REMARKS

APP. NO. 10/627,851

FIGURE 2

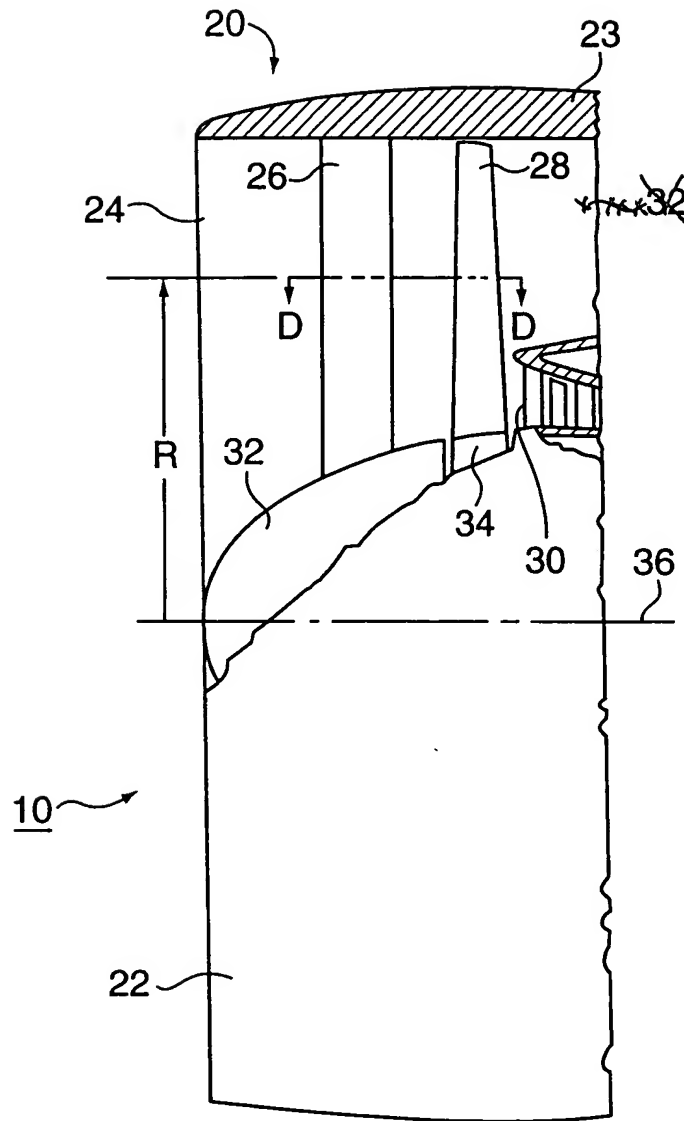
4. Claims 8 and 9. The objection was that the drawings do not show “a propeller for generating thrust used to propel a body through [a] fluid.” This objection is respectfully traversed. The fan shown in Figure 2 generates thrust, and can be considered to be a propeller according to the claim recitation. Of course, the “propeller” recited in the claims is not limited to the rotor of a turbofan engine, but such a rotor does comprise a “propeller” as recited in claims 8 and 9.
